CITY OF ALBUQUERQUE

Re: Sony Imageworks Grading and Drainage Plan
Engineer's Stamp dated 5-8-08 (R16/DA3006)

C100
Grading and
Drainage Plan

Sony Imageworks-Shell
@Mesa del Sol
5640 University Blvd SE
Albuquerque, NM 87119

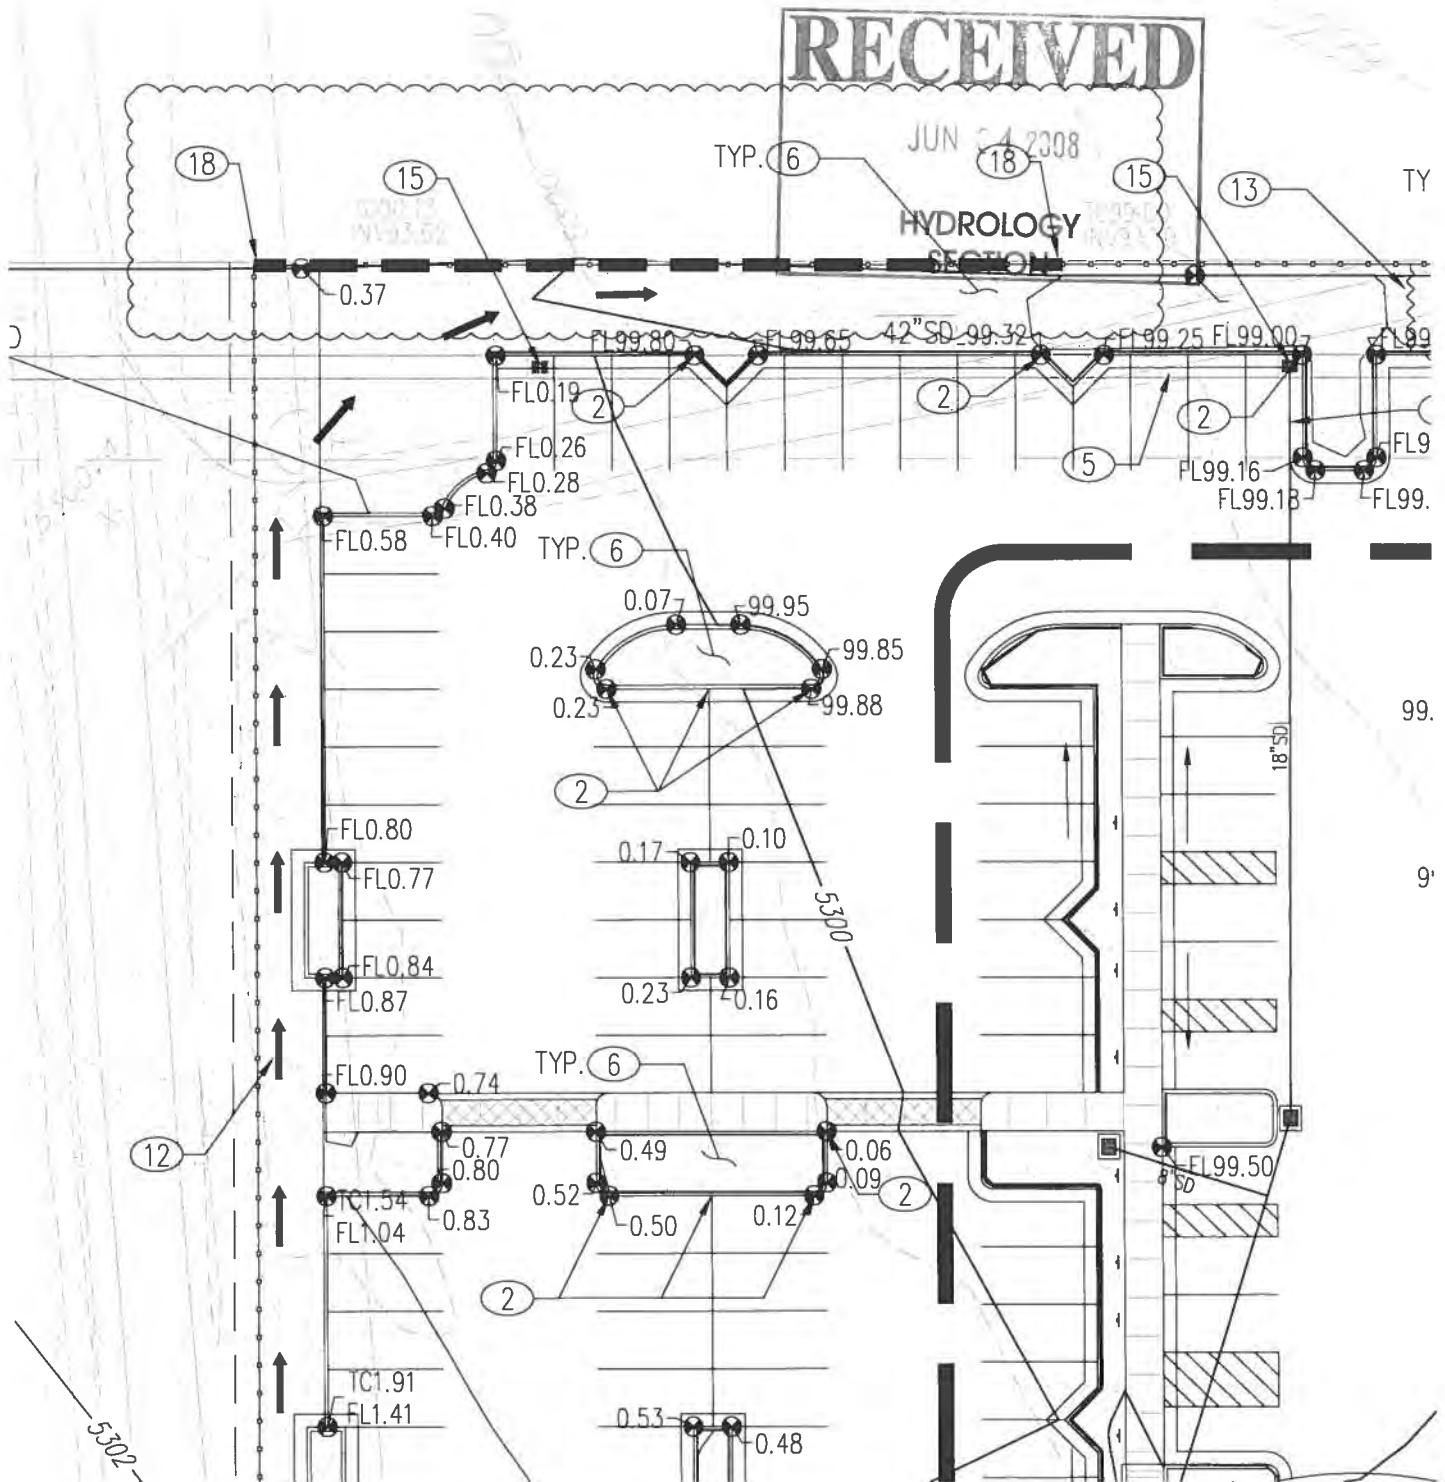
- Engineer Certification per the DPM checklist will be required.
- Include the berm and the berm detail, received 6-4-08, on the certified plan.
- Per the AHYMO data submitted 6-4-08, the max water surface elevation for the pond in Basin 3 is 5298.75. Update this on the certified plan.

'It appears that run-off from the northeast portion of the future parking area will leave the site. A berm may be required along the rear property line to prevent run-off from leaving the site.'

- It appears that runoff from the northeast portion of the future parking area will leave the site. A berm may be required along the rear property line to prevent runoff from leaving this site.

With this letter, we have provided a detail of the drainage control berm that we will issue to the contractor.

18. INSTALL DRAINAGE CONTROL BERM 1' ABOVE FINISHED GRADE, PER DETAIL SHEET 1.1

Add Drainage Control Berm

**GRADING AND
DRAINAGE PLAN**

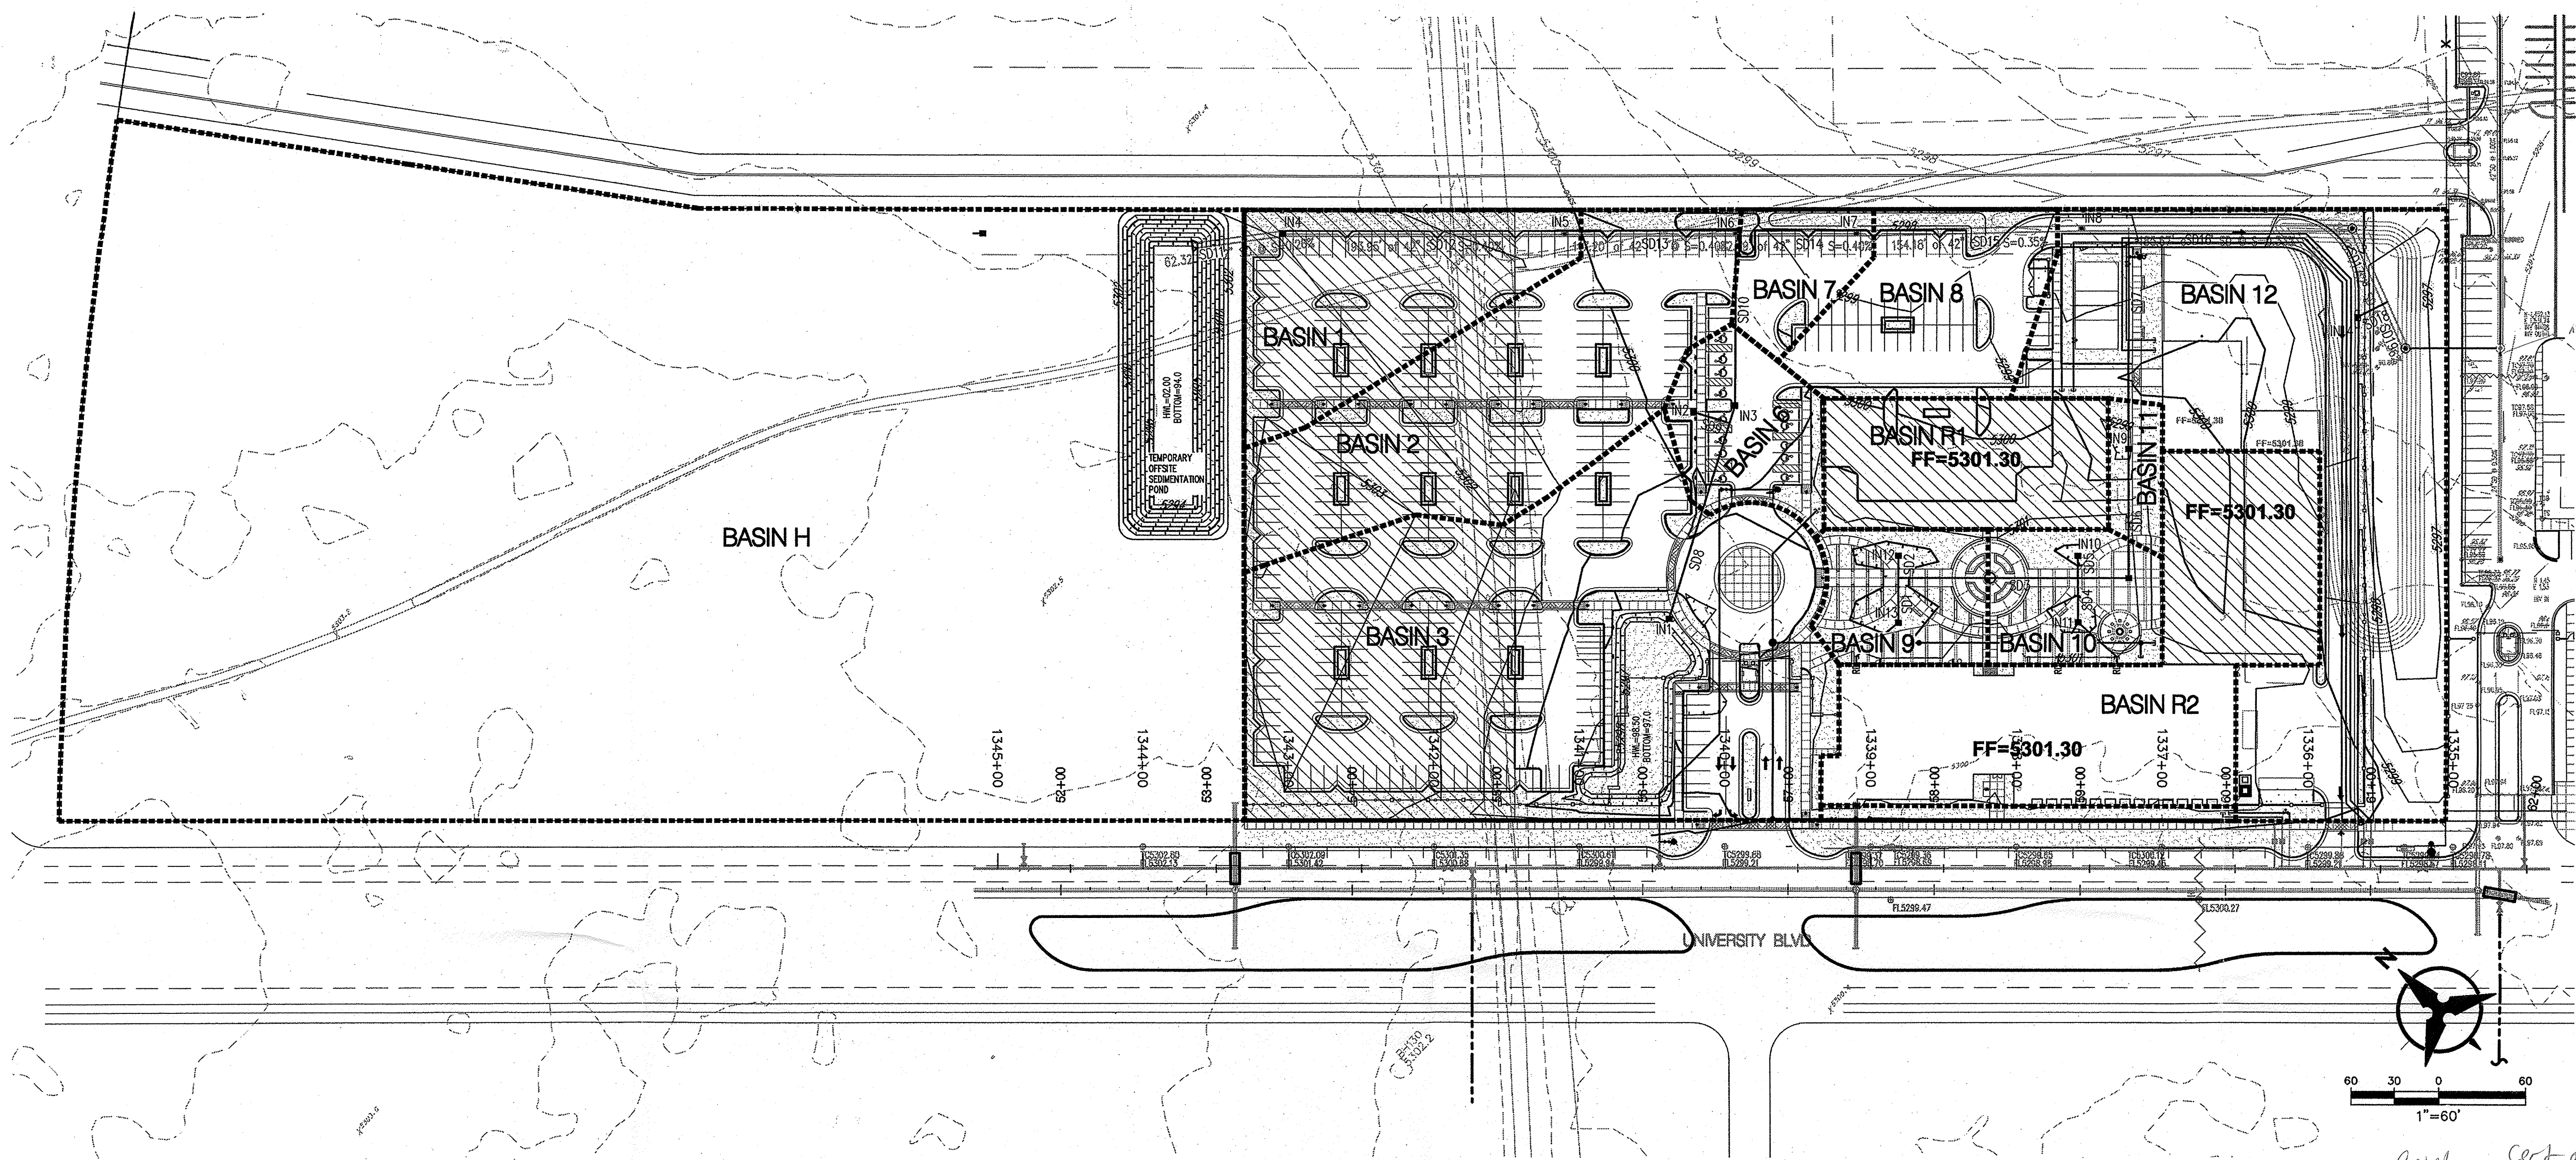
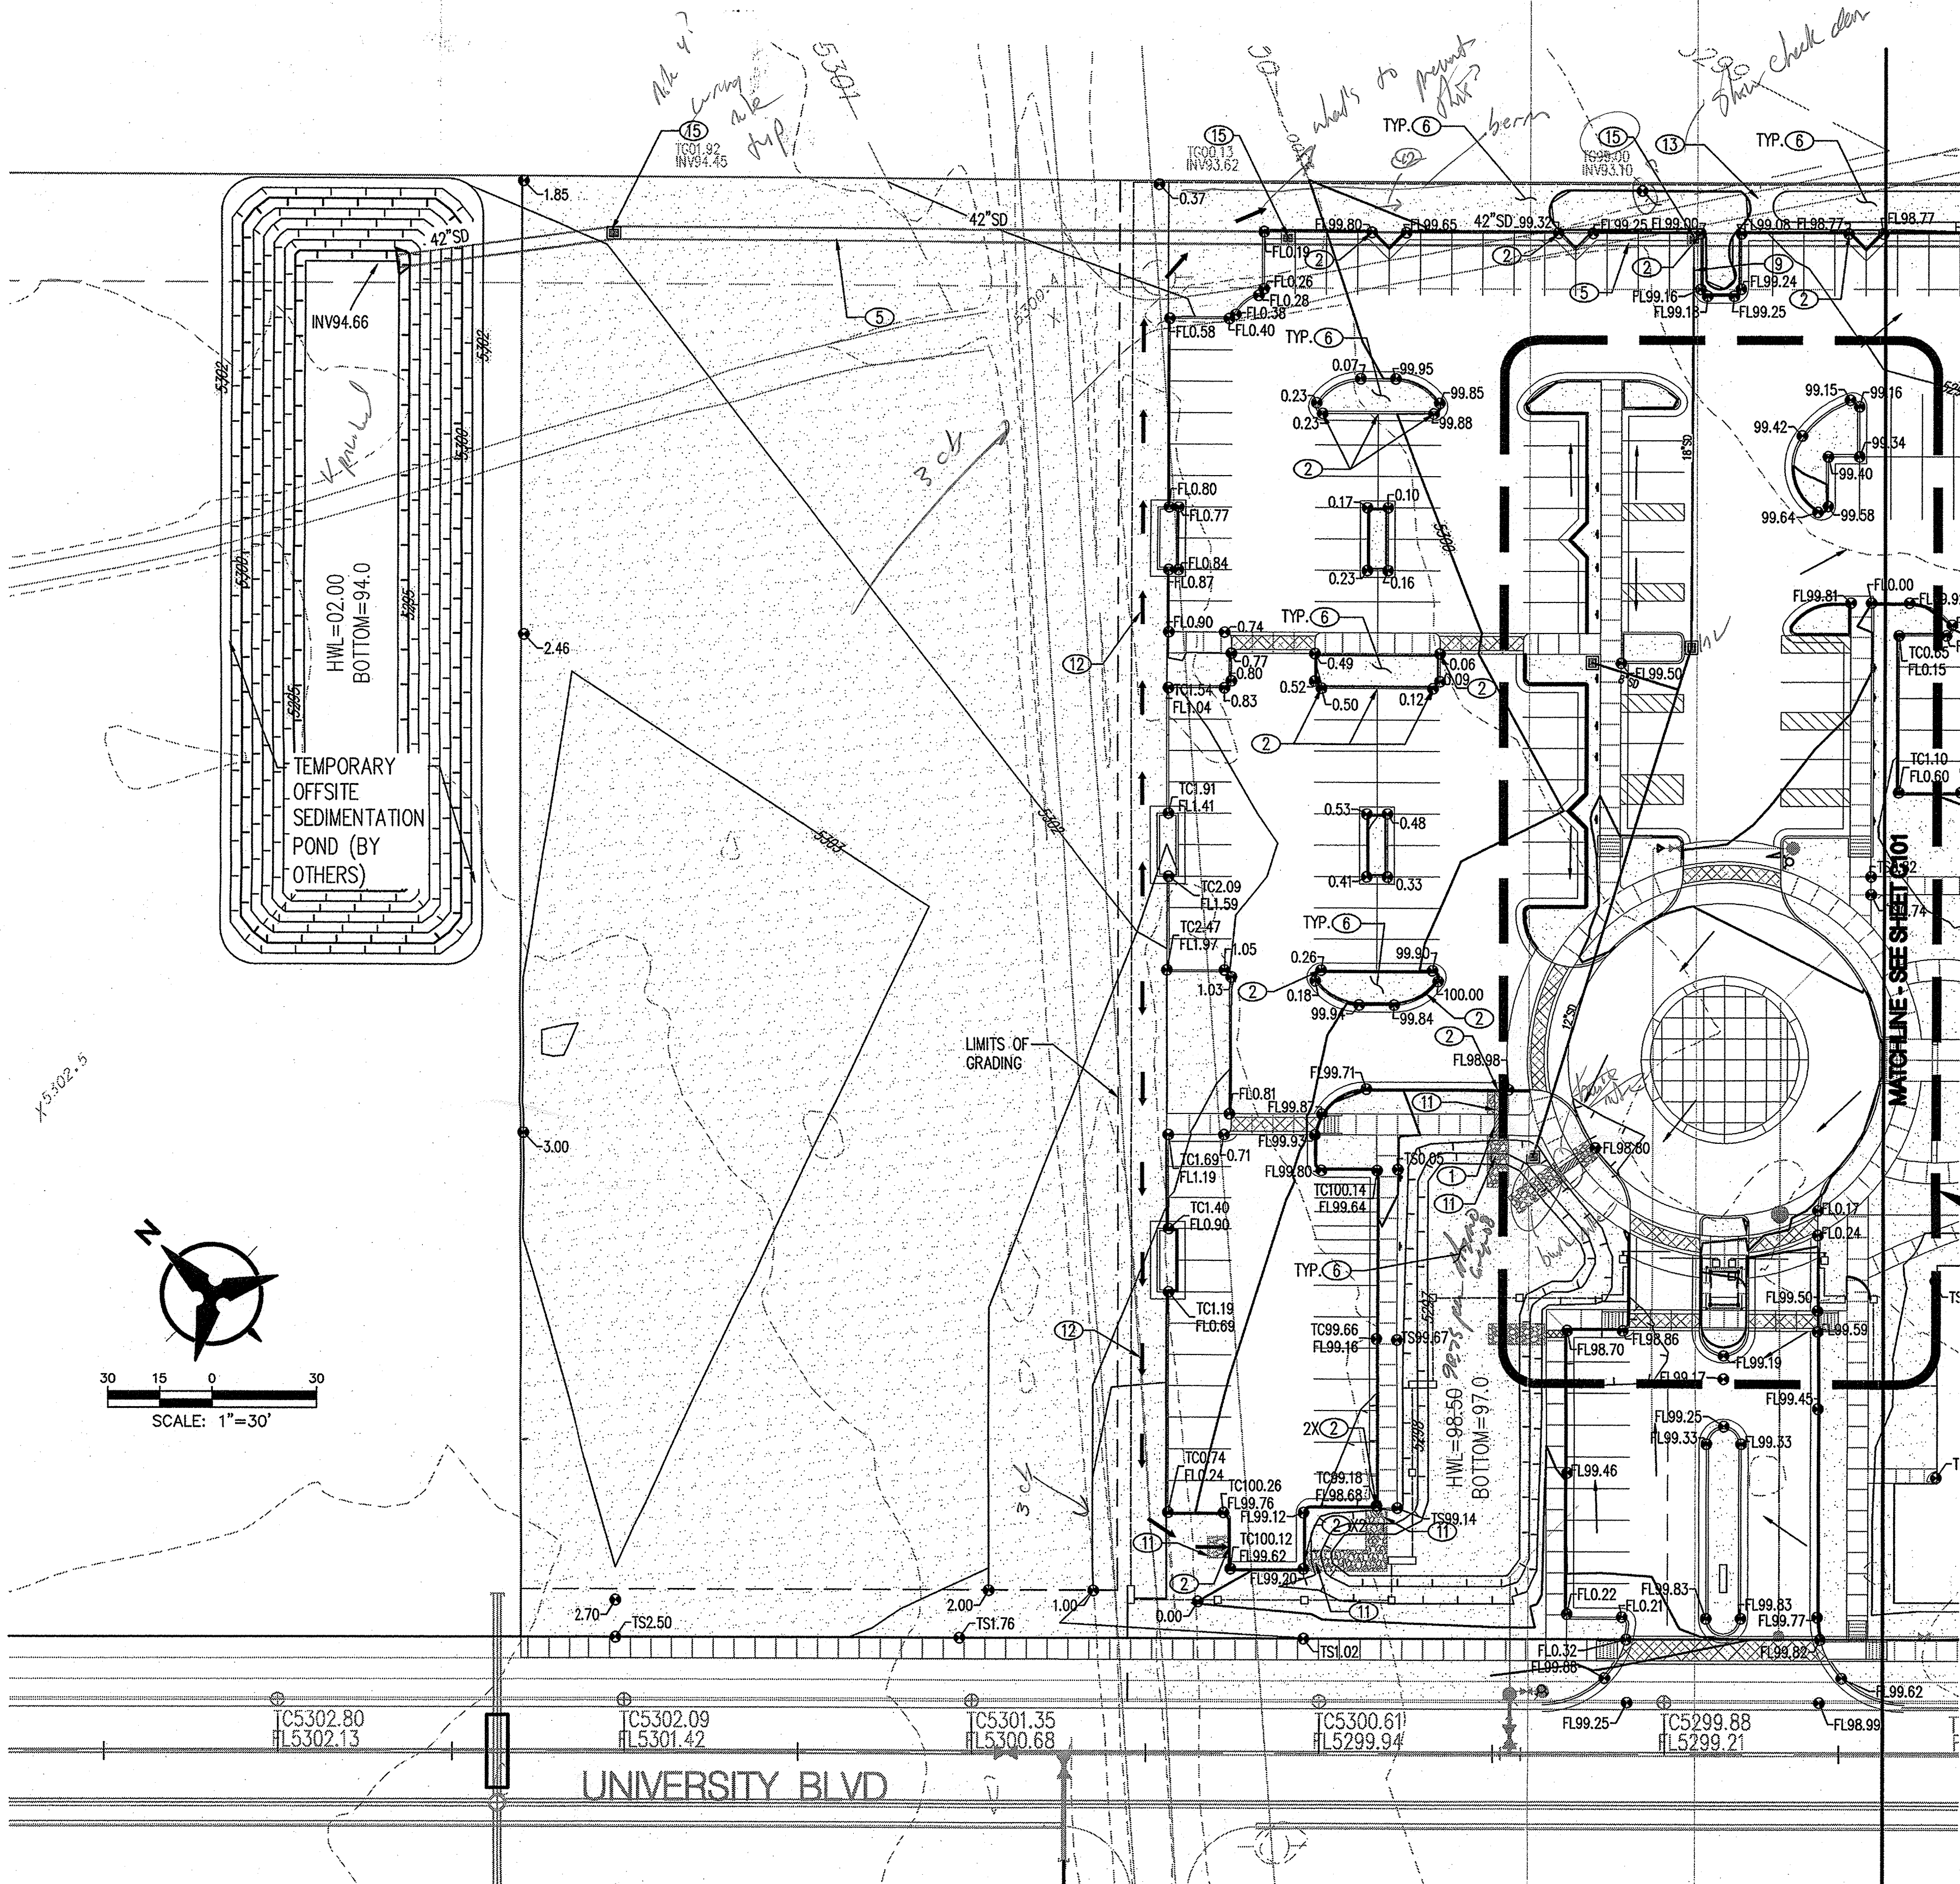
- It is not clear how the pond in Basin 3 will function. The HWL is equal to the grate height at 98.50. The volume provided is 10540 cu. ft., which is less than the 100 yr-6hr storm produces. In addition, the pipe leaving the pond will carry 2.98 cfs and the basin produces 8.5 cfs. Therefore, it appears runoff will overtop the pond and the HWL is not 98.5 as stated. Show the extents of the WSE/HWL in the parking lot if that is your intention. Also, the 24-hour storm is required for ponds of this type. Provide a hydrograph for the pond.

- A manhole is shown on the studios lot where the 36" line comes in from this site. The as-built plan from the studios show a manhole was not constructed. Call out a Tee if that was built and provide an invert.

We have provided documentation with this letter that shows the inlet capacity as the pond fills. The attached AHYMO model demonstrates the 24hr rainfall hydrograph along with the HWL and peak discharge, elevation 98.75 and 2.82 cfs respectively. Therefore, the storm water does not overtop the top of pond at 99.00. Similarly, peak discharge from the basin is 8.5 cfs, but peak discharge from the pond is 2.82 cfs.

We intend to document this change with the drainage certification for the studios.
